Subject: RE: 167 SB layover ID#5309 @ Meats Ave and Canal St NOT SAFE cars park and

1. Canal-Meats (Layover)

Stop ID: 5309

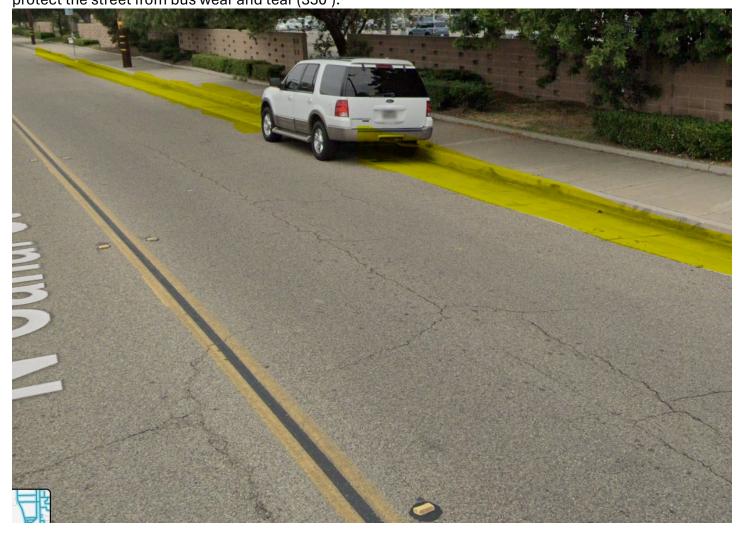
It is requested to place parking restrictions for the length of the "reinforced gutter", which is intended to protect the street from bus wear and tear (350').

2. Canal-Meats (First Stop) Stop ID: 5308 There is also a stop prior to the layover, which could also use parking restrictions. Since buses make a right turn, starting from start of curb to the end of the "reinforced gutter" (130').
